Repvblik is pleased to present our updated plans for the conversion of the existing Madison Plaza Hotel at 3841 E Washington Avenue into multifamily apartments for final approval with the Urban Design Commission.

Initial Approval: September 7th, 2022

Commission Feedback & Repvblik Response:

RENOVATION
PLATO'S MADISON, WI
3841 E WASHINGTON AVE, MADISON, WI 53714

SHEET TITLE
 PHOTOMETRICS

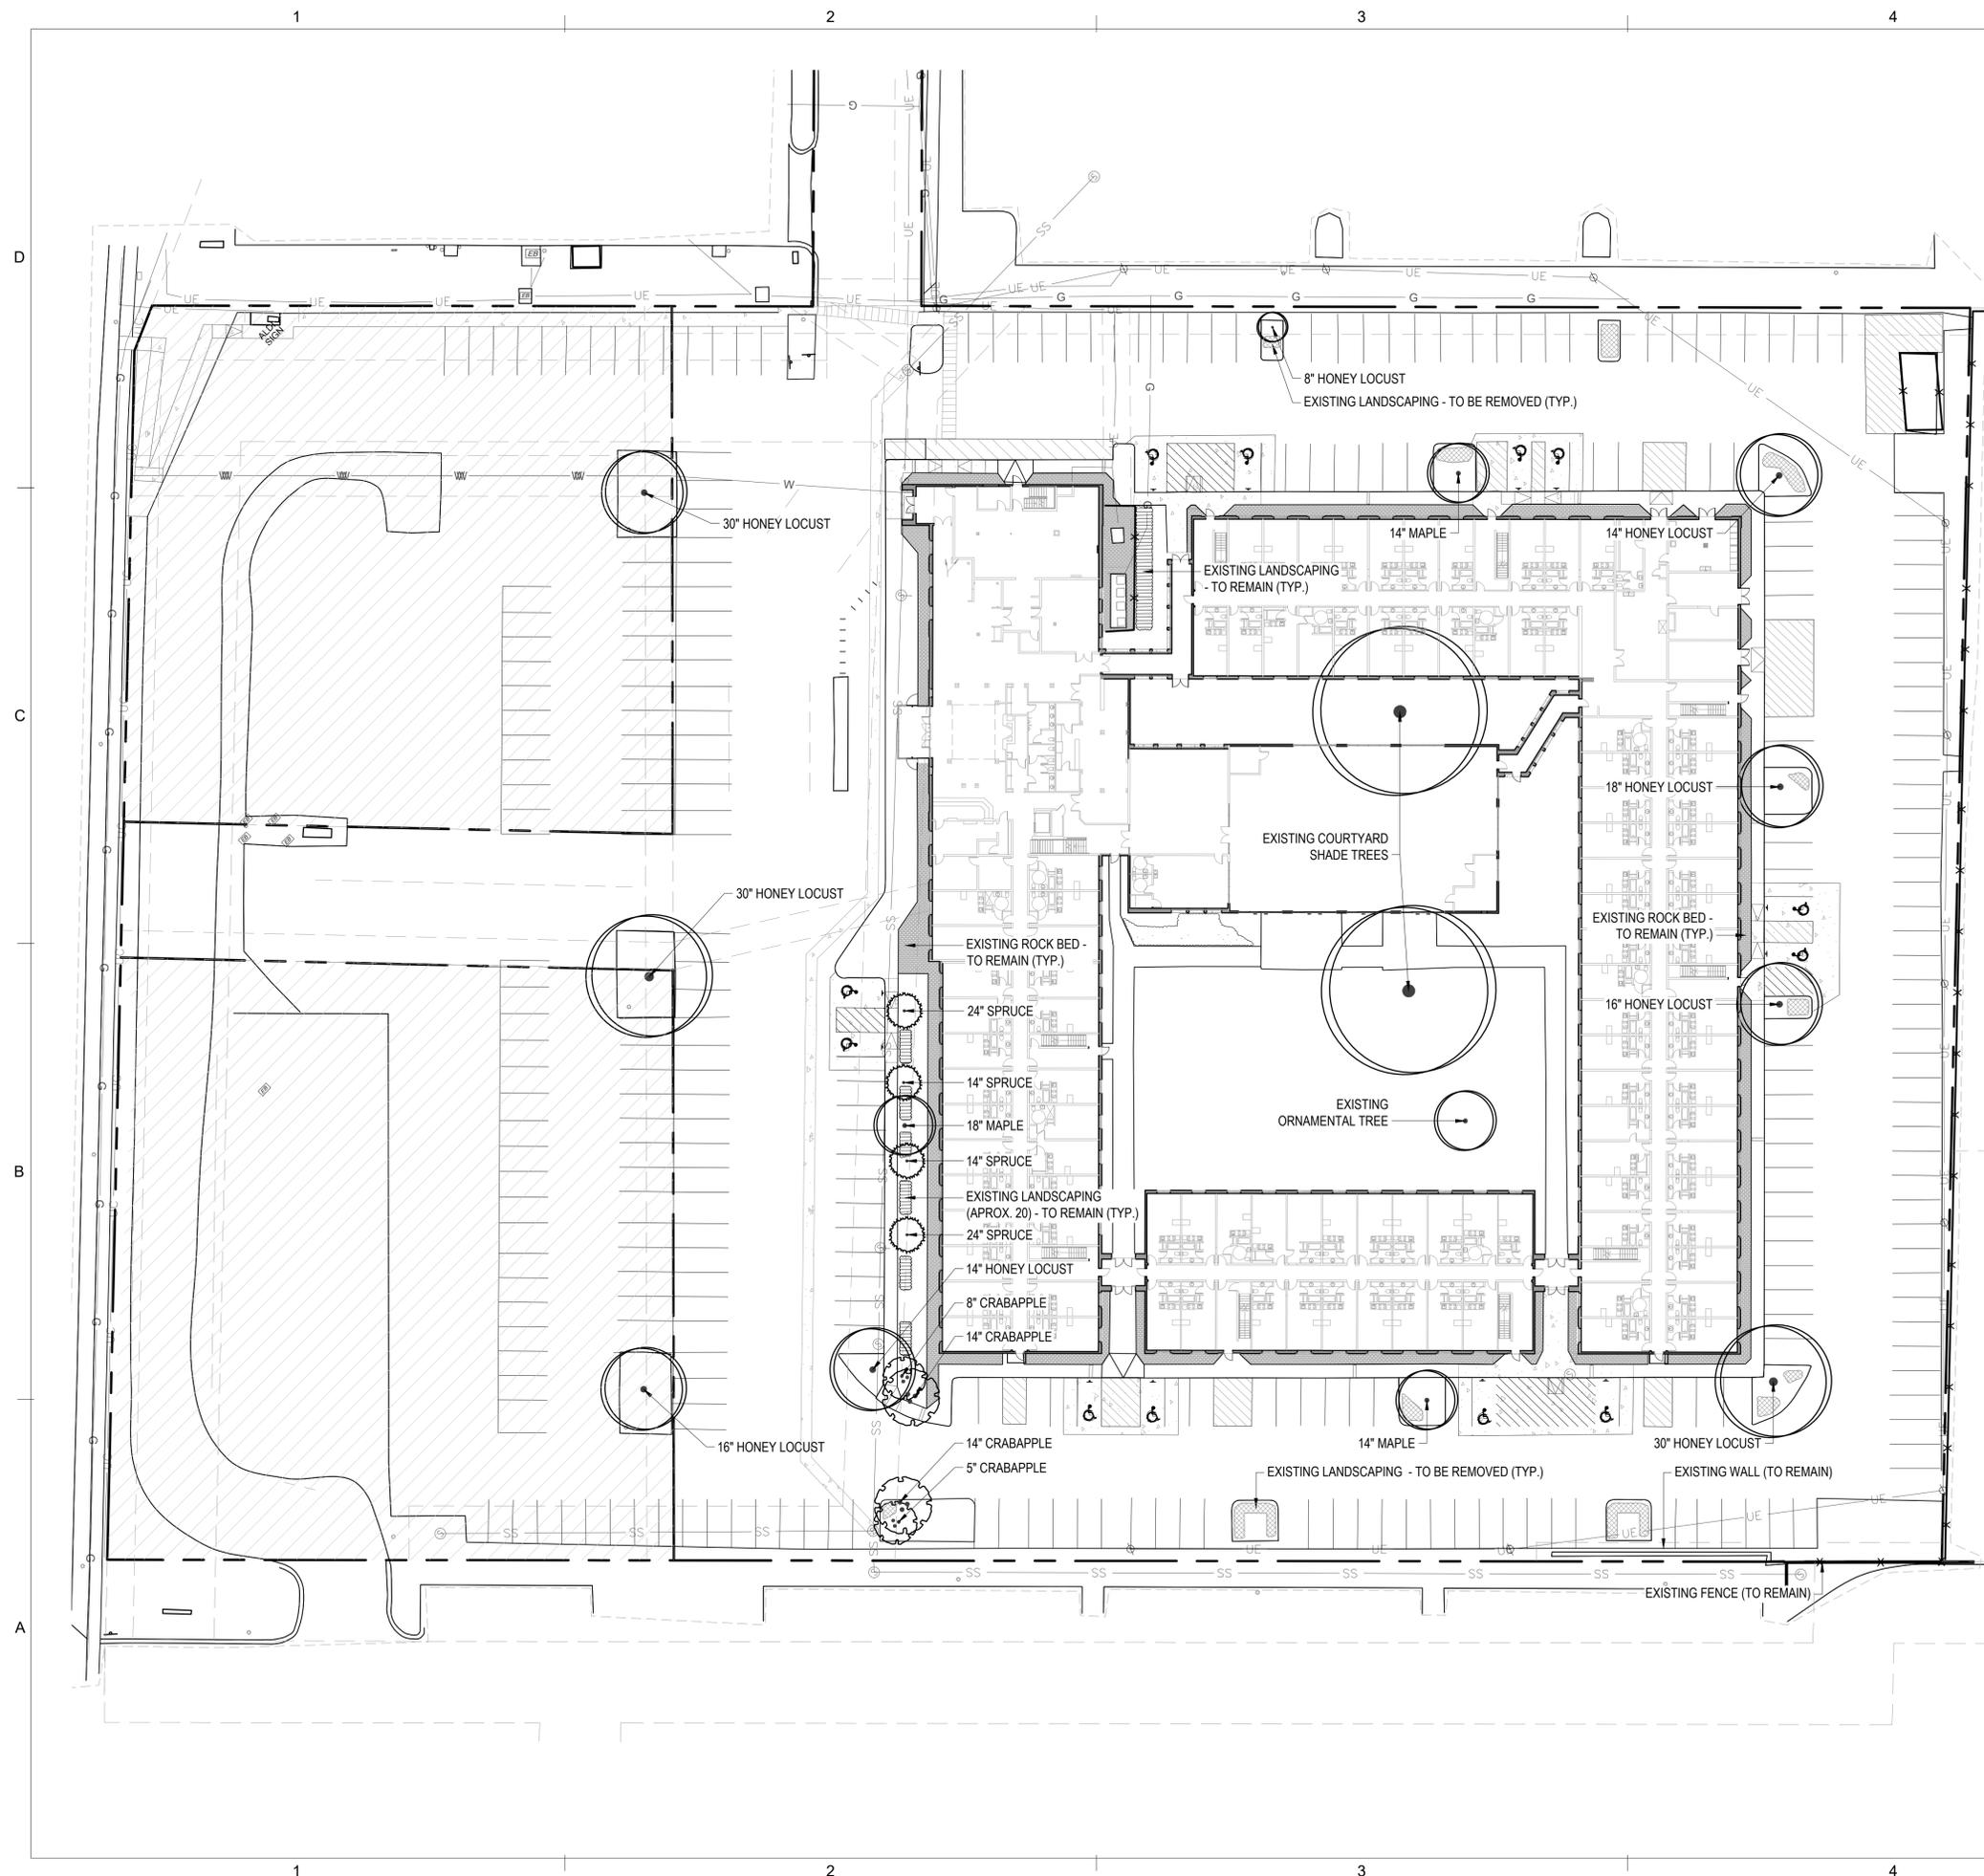
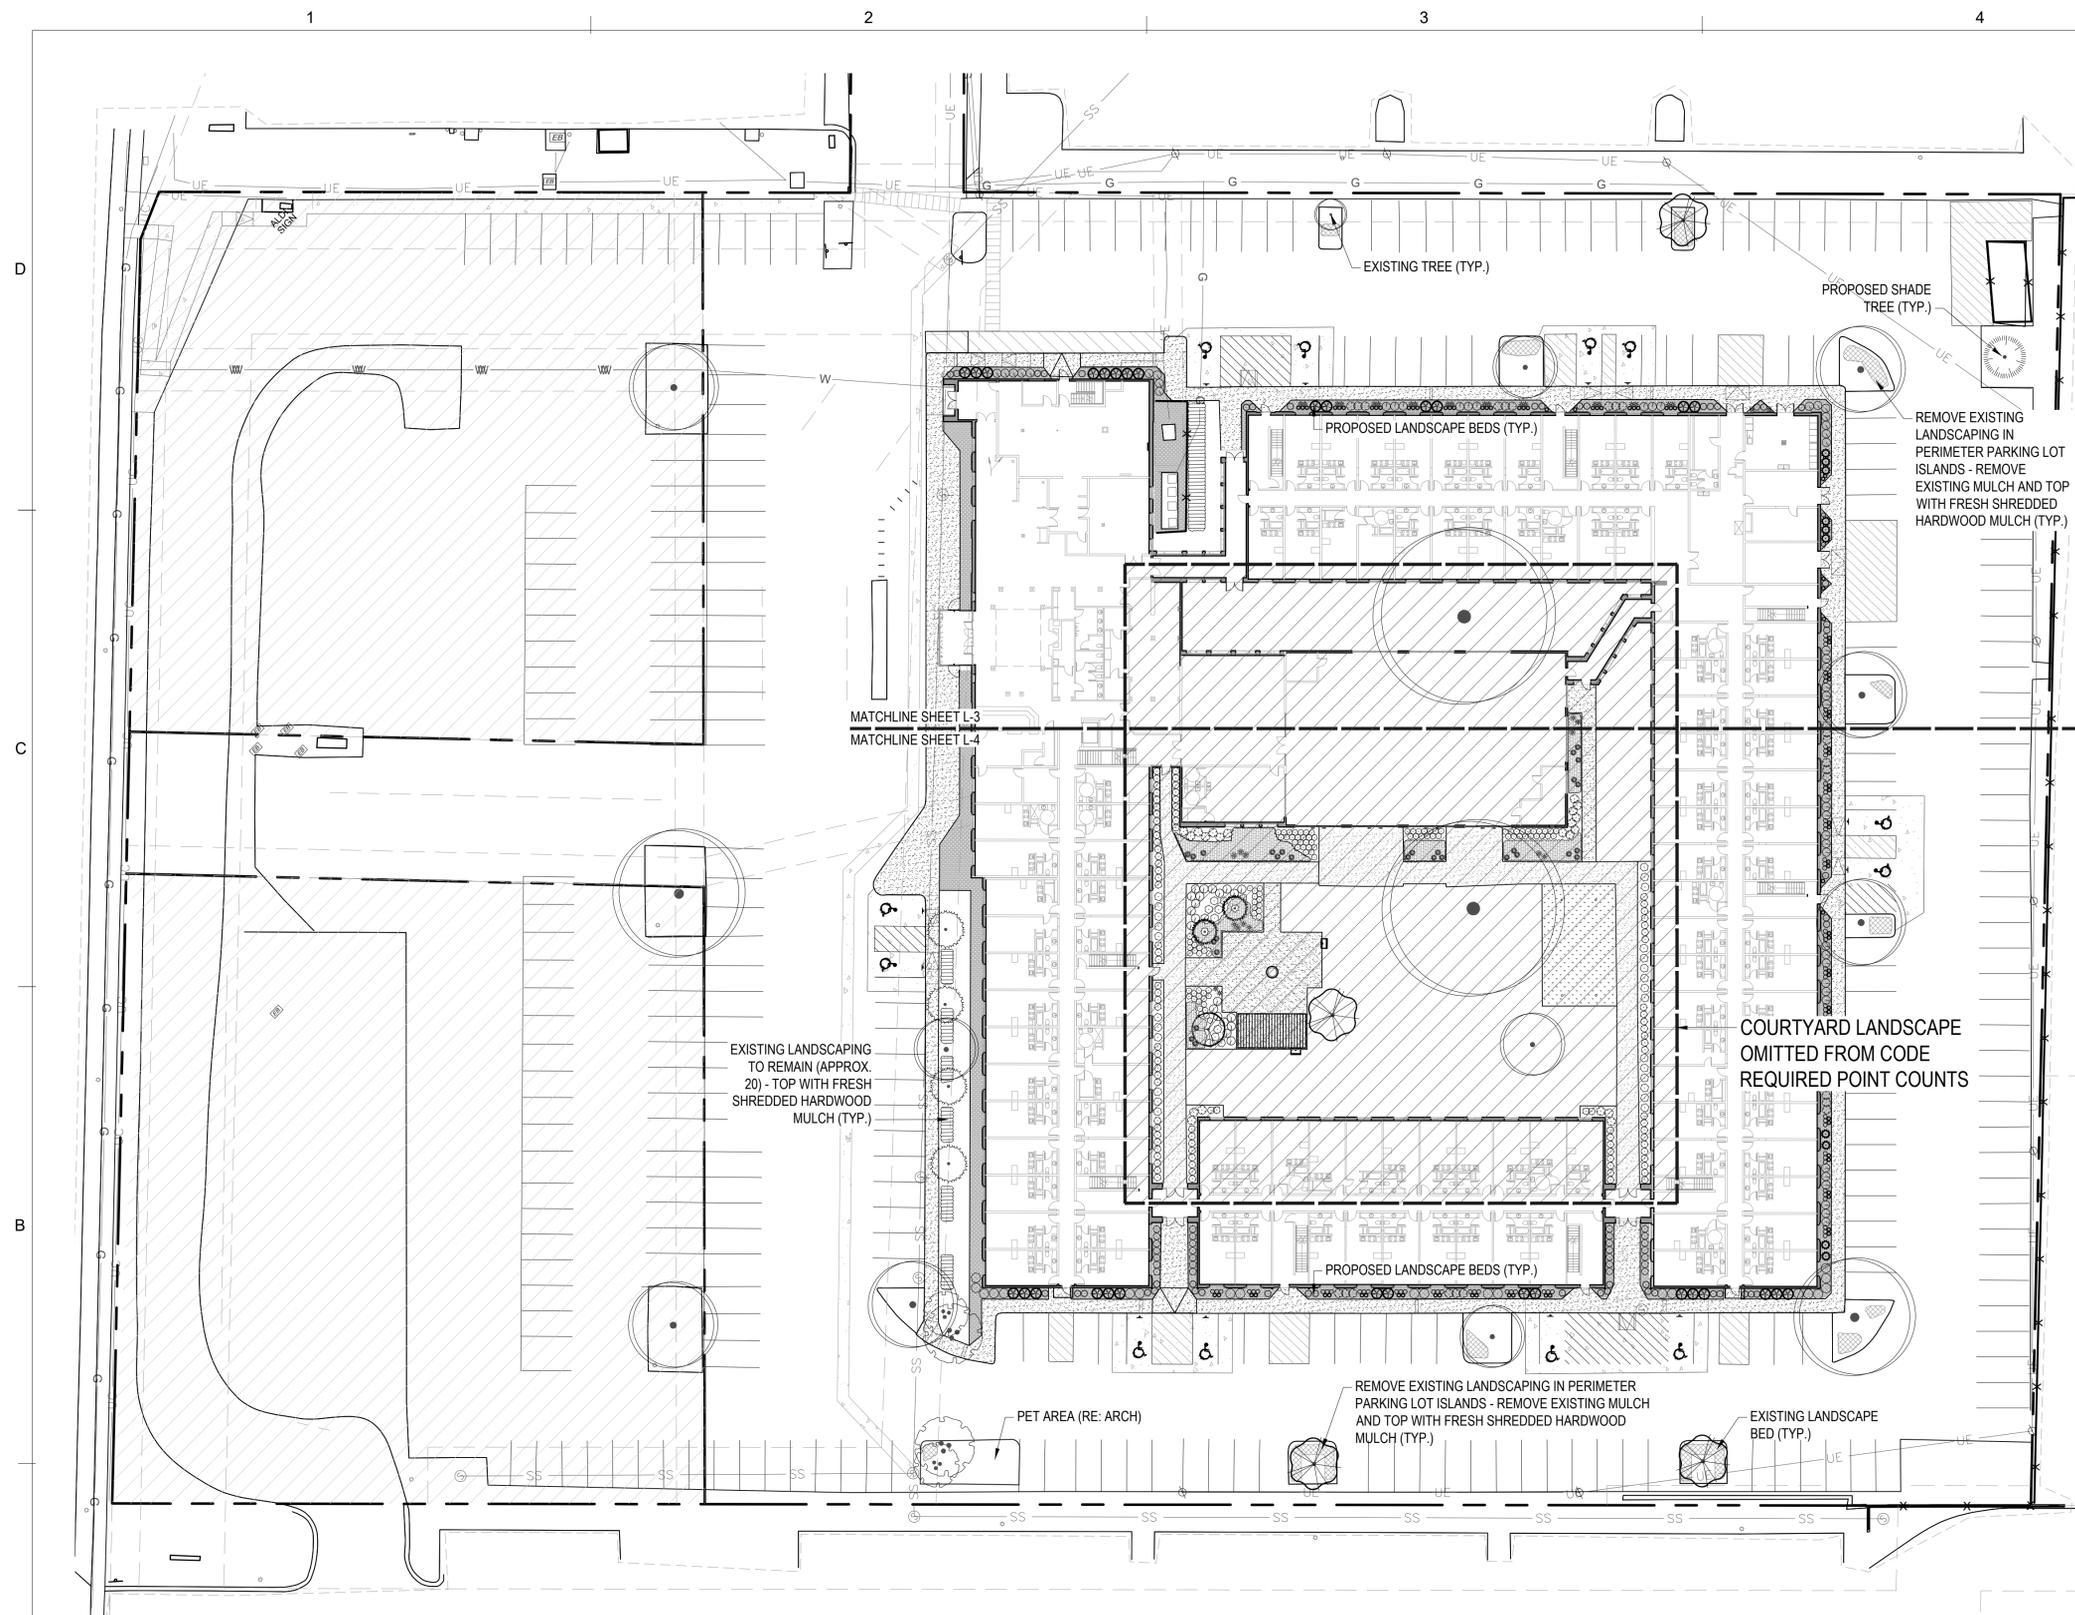
2. The applicant shall update the photometric plan that responds to the concerns in the staff report, including lighting in the courtyard and along pedestrian pathways.

- a. *An updated photometric plan is attached herein.*
3. The applicant shall update the elevations to address architectural comments, including:
 - a. Updating the color of the downspouts and gutters to match the exterior wall color,

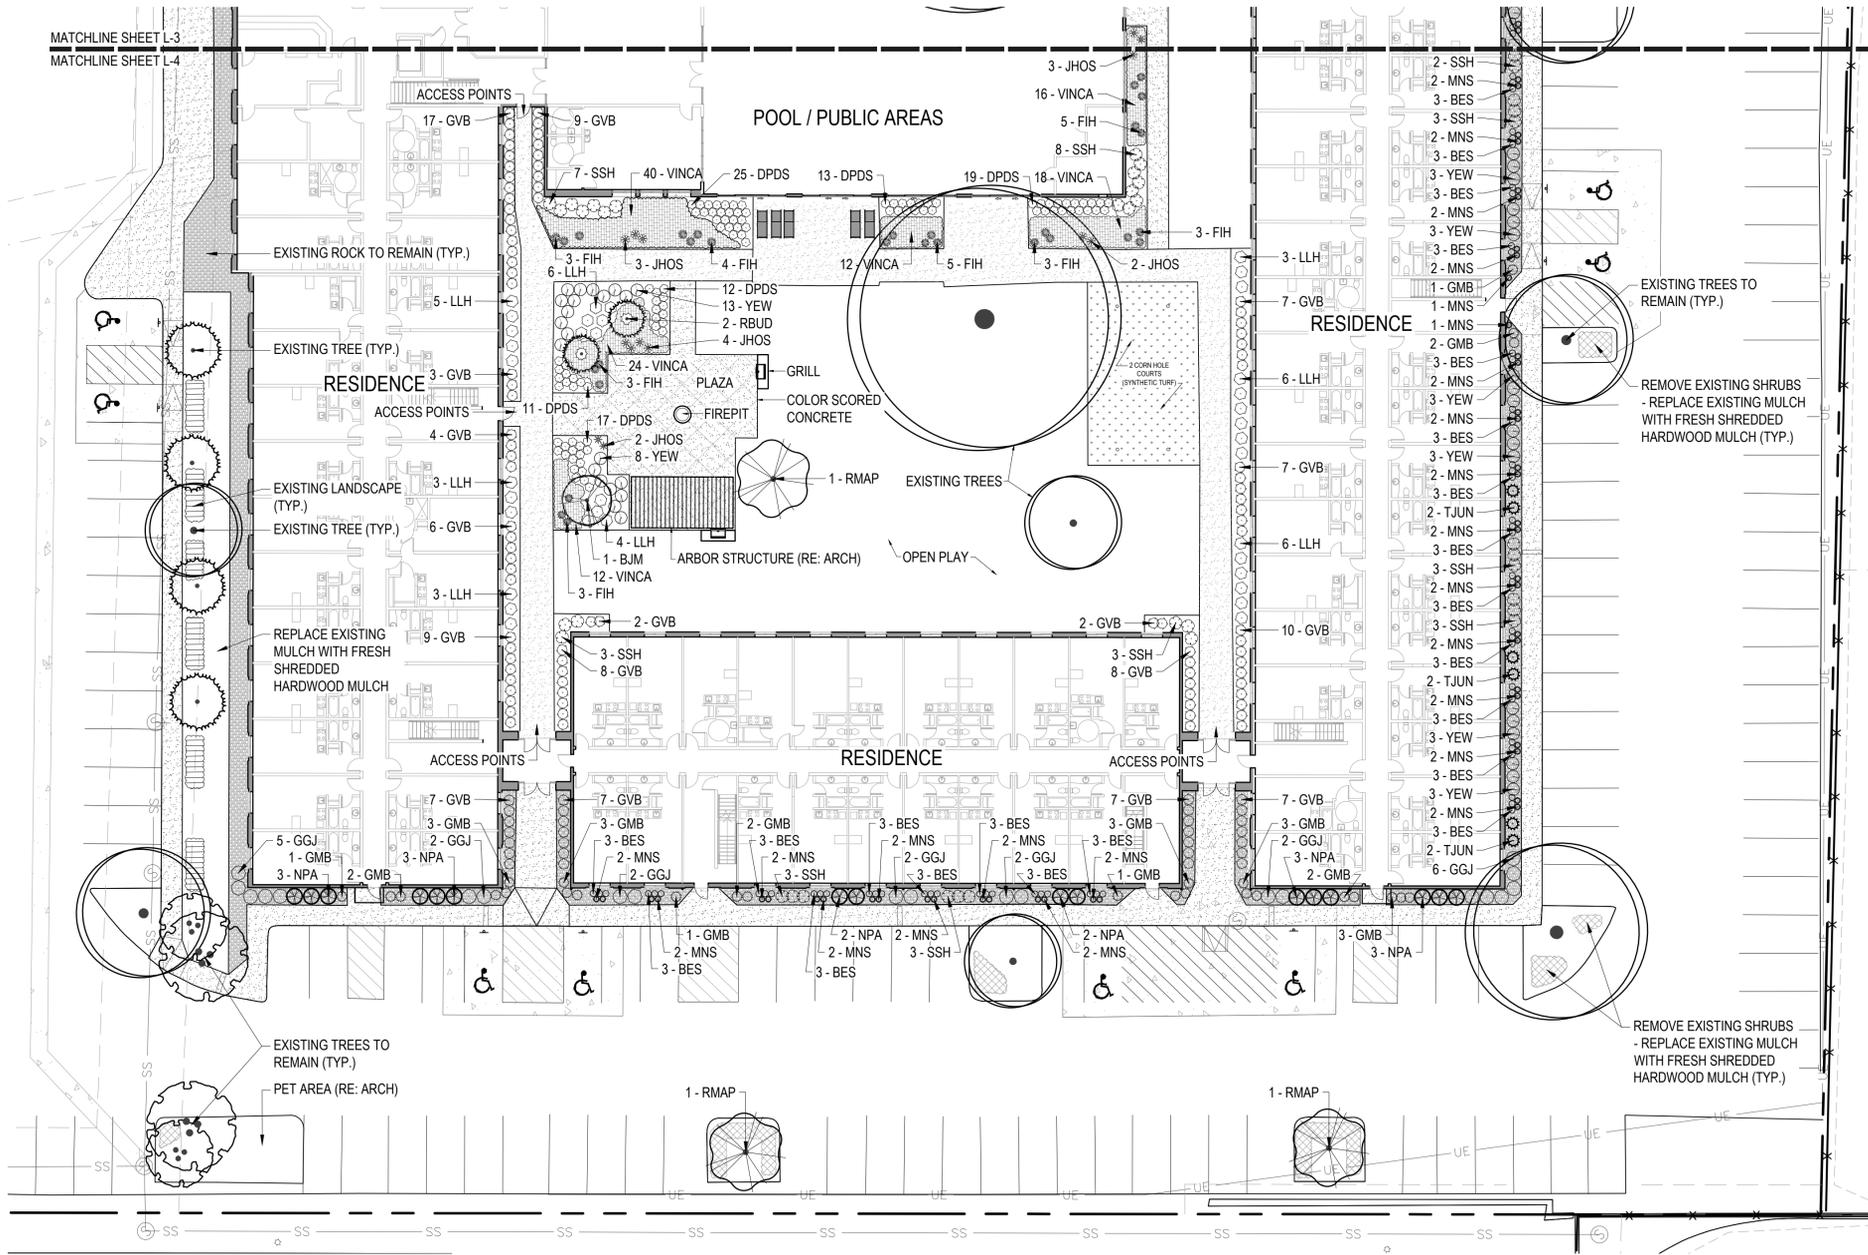
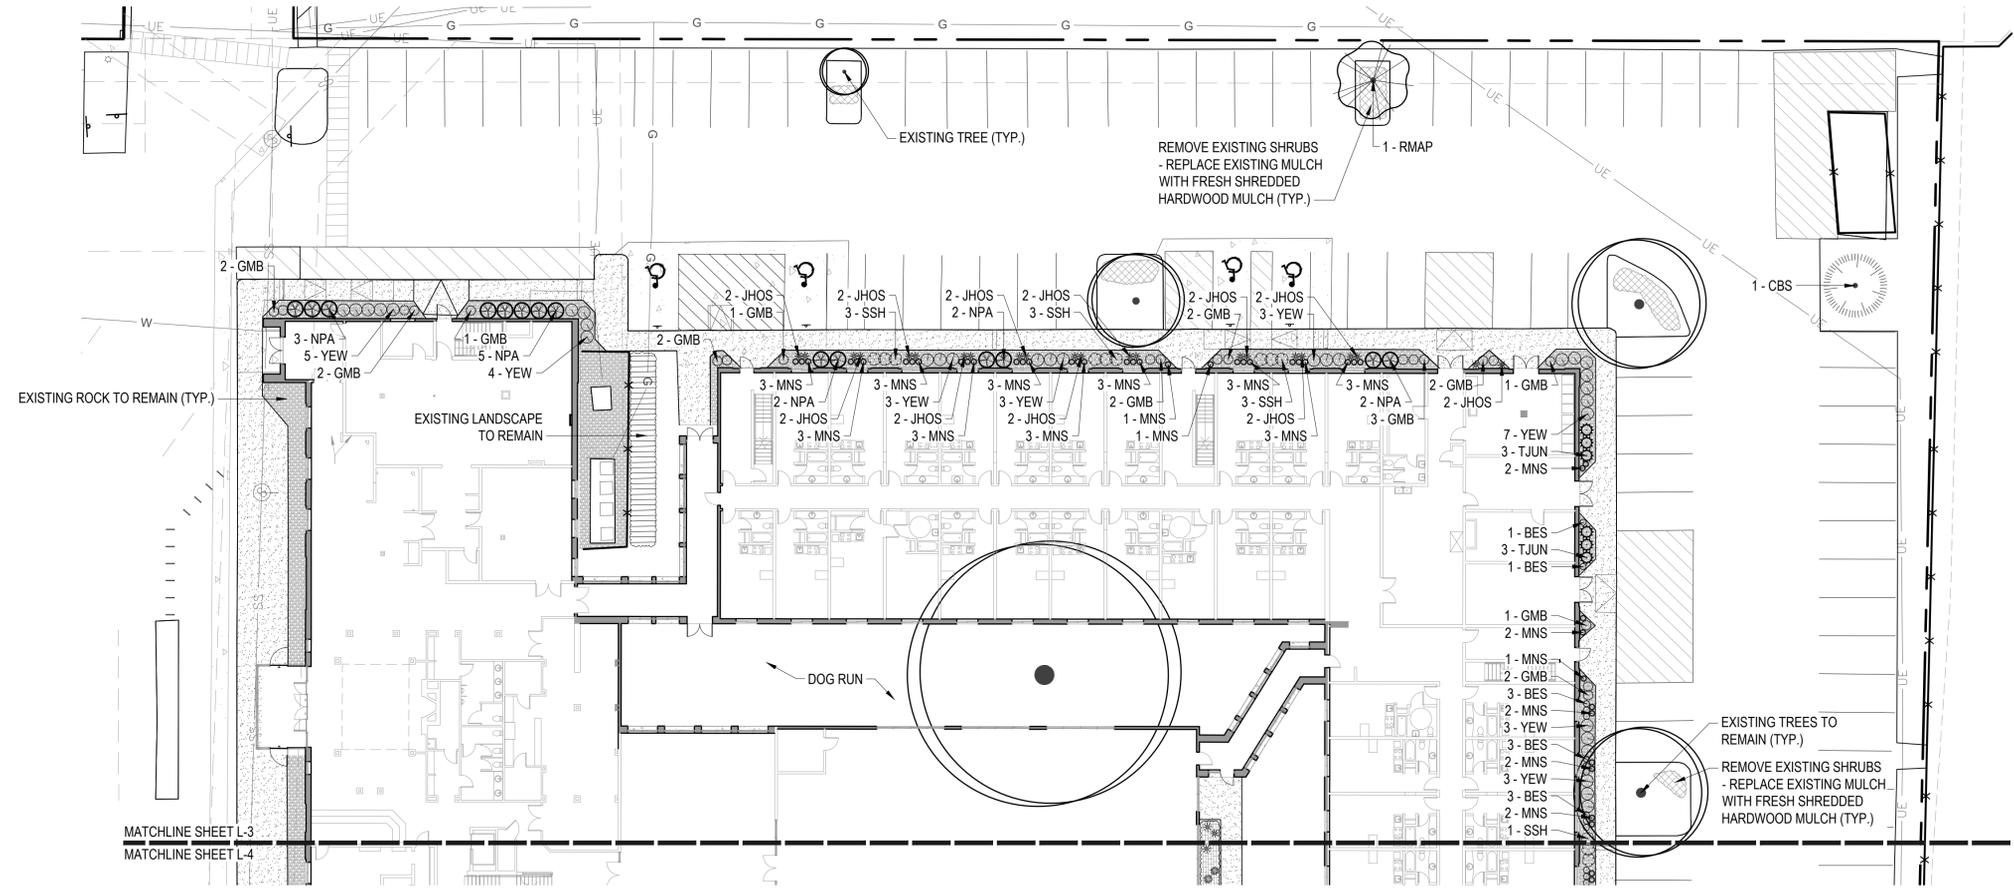
1. The applicant shall provide a landscape plan as part of the Final Approval application, including plantings in the courtyard space and the use of bark mulch.

- a. *A landscape plans are attached herein. We have updated the courtyard landscaping significantly. Where there is exposed earth or mulch beds in the landscape islands around the building, we will enhance the planting in those areas and add fresh bark mulch. This also includes bark mulch in the courtyard space unless directed otherwise.*
